PIC24FJ256DA210 Family Silicon Errata and Data Sheet Clarification

The PIC24FJ256DA210 family devices that you have received conform functionally to the current Device Data Sheet (DS39969B), except for the anomalies described in this document.

Data Sheet Clarifications

The following typographic corrections and clarifications are to be noted for the latest version of the device data sheet (DS39969B):

FIGURE 2-3 FREQUENCY vs. ESR PERFORMANCE FOR SUGGESTED VCAP

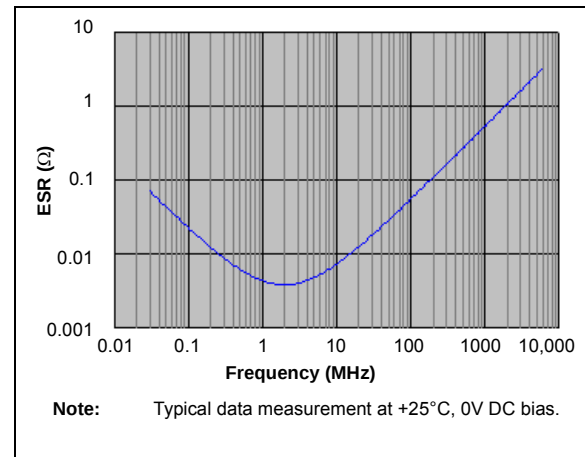
Section 2.4 “Voltage Regulator Pins (ENVREG/DISVREG and VCAP/VDDCORE)” has been replaced with a new and more detailed section. The entire text follows:

When the regulator is enabled, a low-ESR ($< 5\Omega$) capacitor is required on the VCAP pin to stabilize the voltage regulator output voltage. The VCAP pin must not be connected to VDD and must use a capacitor of 10 μF connected to ground. The type can be ceramic or tantalum. Suitable examples of capacitors are shown in [Table 2-1](#). Capacitors with equivalent specifications can be used.

Designers may use [Figure 2-3](#) to evaluate ESR equivalence of candidate devices.

The placement of this capacitor should be close to VCAP. It is recommended that the trace length not exceed 0.25 inch (6 mm). Refer to **Section 30.0 “Electrical Characteristics”** for additional information.

FIGURE 2-4 DC BIAS VOLTAGE vs. CAPACITANCE CHARACTERISTICS

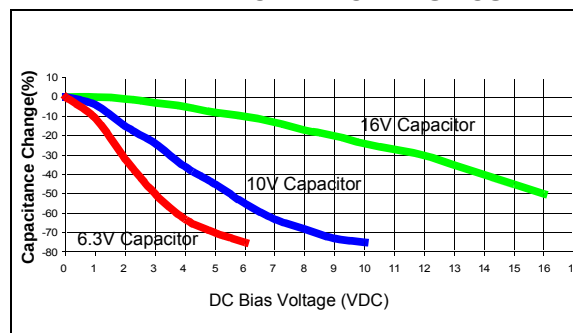
In addition to temperature tolerance, the effective capacitance of large value ceramic capacitors can vary substantially, based on the amount of DC voltage applied to the capacitor. This effect can be very significant, but is often overlooked or is not always documented.

A typical DC bias voltage vs. capacitance graph for 16V, 10V and 6.3V rated capacitors is shown in Figure 2-4.

When selecting a ceramic capacitor to be used with the internal voltage regulator, it is suggested to select a high-voltage rating, so that the operating voltage is a small percentage of the maximum rated capacitor voltage. For example, choose a ceramic capacitor rated at 16V for the 1.8V V_{CAP} voltage. Suggested capacitors are shown in Table 2-1.

FIGURE 30-1: PIC24FJ256DA210 FAMILY VOLTAGE-FREQUENCY GRAPH (INDUSTRIAL)

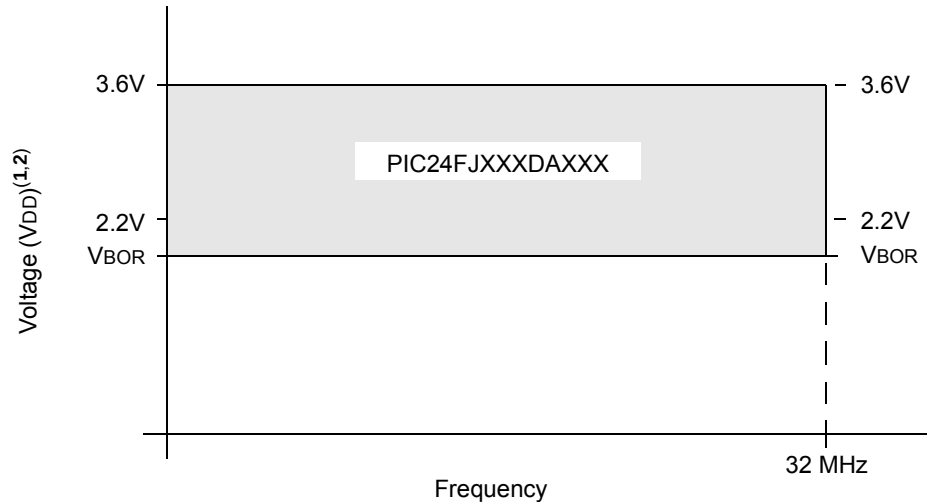
Figure 30-1 (“PIC24FJ256DA210 Family Voltage-Frequency Graph”) is amended by adding an additional footnote. The updated figure is shown below (changes in **bold**; bold in original removed for clarity).

2: When the USB module is enabled, V_{USB} should be provided at 3.0V to 3.6V. When the USB module is not enabled, the wider limits shaded in grey apply. The voltage on the V_{USB} pin should be maintained at (V_{DD} – 0.3V) or greater. Optionally, the pin may be left in a high-impedance state when the USB module is not in use, but doing so may result in higher I_{PD} currents than specified.
